**Project #21-039  
Renewal Mixed Use Housing  
Located at approximately 89 West 300 South**

**REPORT SUMMARY...**

<i>Project Name:</i>	Renewal Mixed Use Housing
<i>Proponent / Owner:</i>	Christian Wilson / Rod Rounds, DHZ LLC, Triio Group
<i>Project Address:</i>	~ 89 West 300 South
<i>Request:</i>	Design Review Permit
<i>Current Zoning:</i>	Mixed Use (MU)
<i>Type of Action:</i>	Quasi-Judicial
<i>Hearing Date</i>	August 12, 2021
<i>Submitted By:</i>	Russ Holley, Senior Planner

Staff recommends that the Planning Commission **conditionally approve** a Design Review Permit for Project #21-039, Renewal Mixed Use Housing, in the Mixed Use (MU) zone located at approximately 89 West 300 South, TIN #02-048-0004, 02-048-0006 - 0013.

DRAWING TITLE  
DESIGN REVIEW

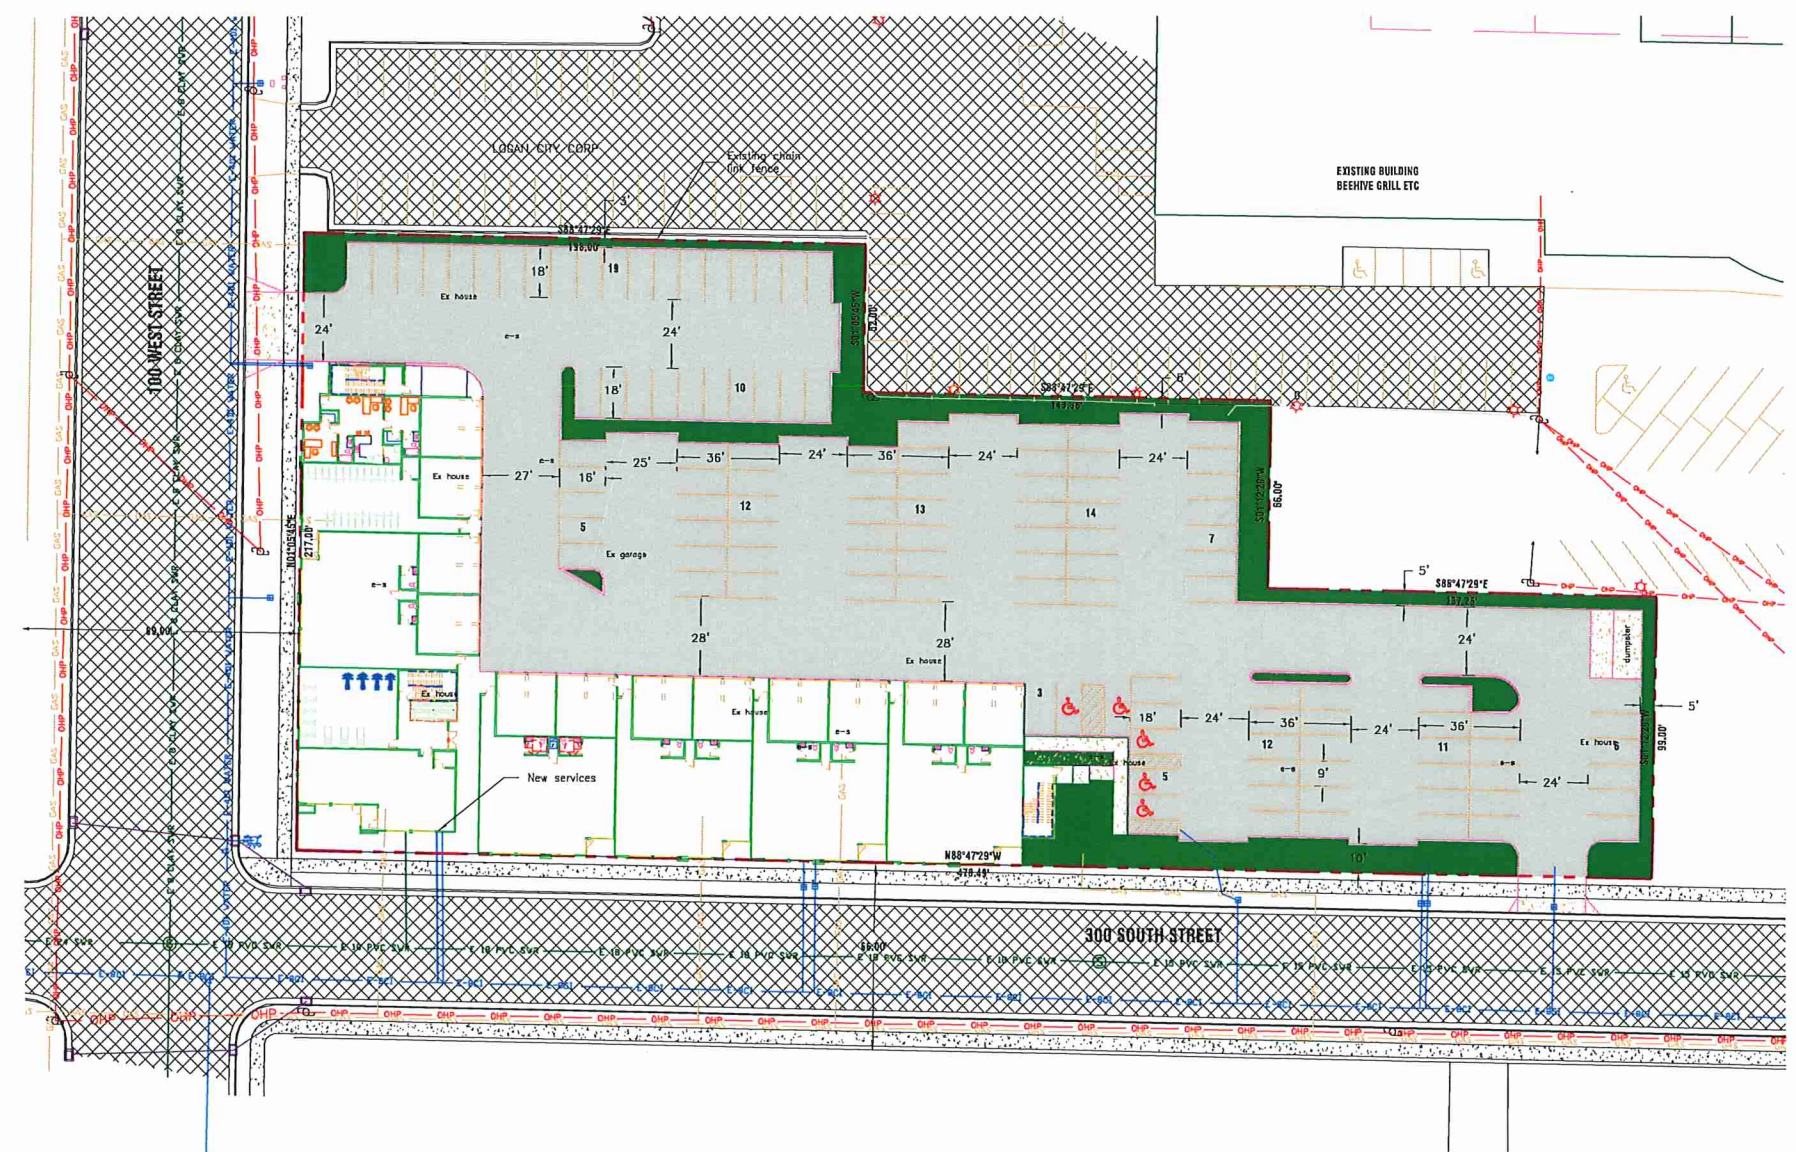
The proposed project meets all setbacks except for the north rear parking setback. The LDC 17.32 allows parking setbacks to be adjusted by the Planning Commission if additional landscaping and features such as berms/walls are installed to sufficiently screen/buffer parking lots or if adjacent to existing parking lots setbacks can be eliminated but total interior landscaping minimums applies. As conditioned with minimum parking lot landscaping the project complies with the LDC.

The LDC 17.30 require projects to provide pedestrian and street connectivity. The proposed site layout places the building near the sidewalk edge making walking quick and convenient. The east entrance into the stairway corridor does not connect to the adjacent sidewalk along 300 South. As conditioned with a sidewalk connection at the east side of the building, the project meets the requirements in the LDC.

6. A sidewalk connection between 300 South and the east building entrance shall be made.

- c) 18 SF of interior parking lot landscaping shall be provided per parking stall contained within the surface parking area as per LDC.
  - d) A Type "D" buffer shall be used for areas of the parking lot with a setback less than 5 feet.

TITLE	SOUTH AND WEST ELEVATIONS
PROJECT	100 WEST HOUSING - RENEWAL
CLIENT	KEVIN ALLEN, BLAKE DUSTELER, MICHAEL JEWELL
ADDRESS	100 WEST 300 SOUTH, LOGAN, UT, 84321

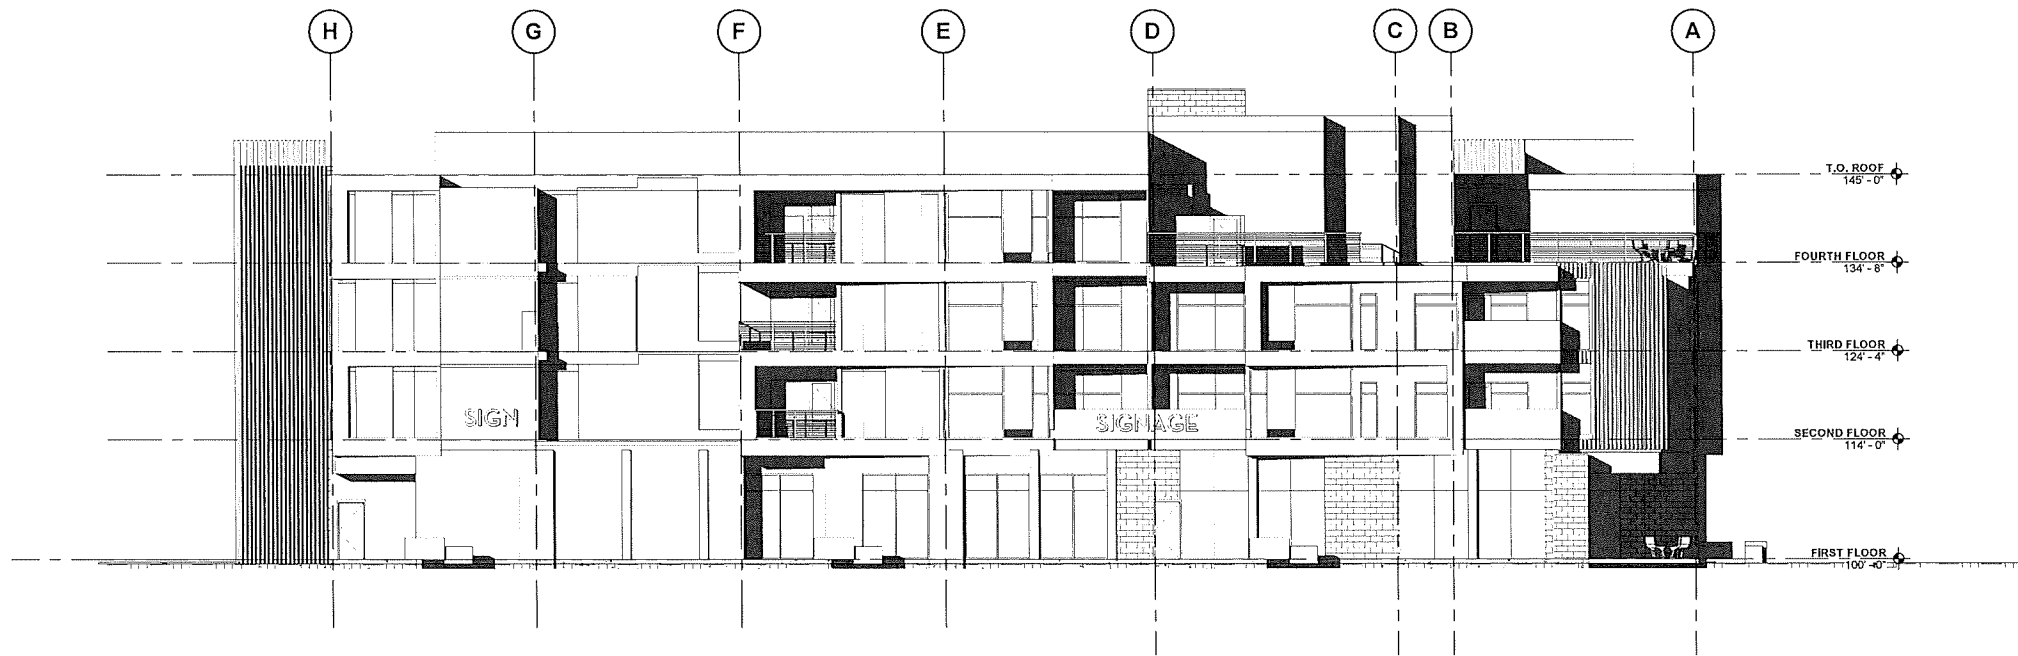
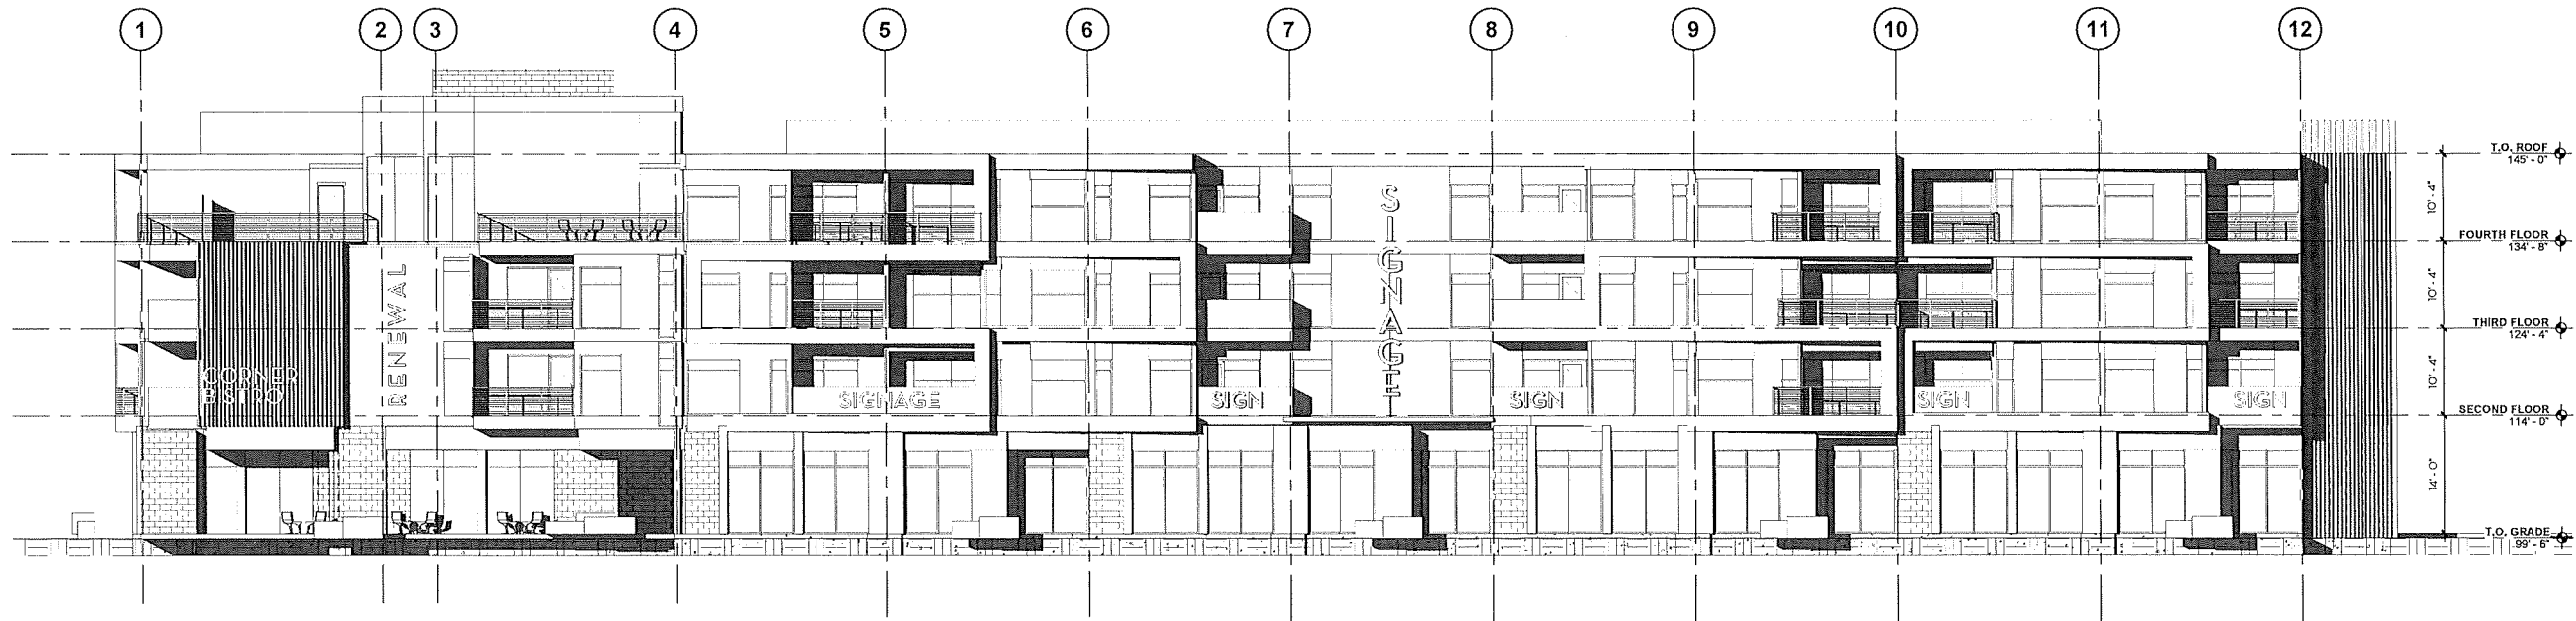
The LDC 17.12 indicates that buildings in the MU zone shall vary from one another, have four-sided architecture and a mix of materials. Acceptable building materials are masonry, stucco, fiber-cement board, wood and metal. Material mixes shall wrap all four sides of buildings and blank walls exceeding 40 linear feet are prohibited. Vertical dimensions of blank wall shall not exceed 12 feet and roof forms should be varied for visual interest. Buildings shall be oriented to the street with primary entrances facing towards the street. Secondary entrances should face the side or rear. Commercial/Mixed Use buildings are required to have 50% transparency (fenestration) along ground-floor street frontages and residential buildings are required to have 15% transparency along street frontages. The proposed building elevations show numerous design features and at least 50% fenestration along ground floor street facing areas with the

exception of the northwest portion of the building (approx. 48 feet). That area, which is shown as the leasing office, does not contain fenestration along the street. As conditioned with 50% fenestration along 100 West, the project meets the requirements in the LDC.

7. The ground floor commercial areas of the building shall have 50% transparency along the street facing portions.
8. Ground floor height shall be at least 12 feet tall.
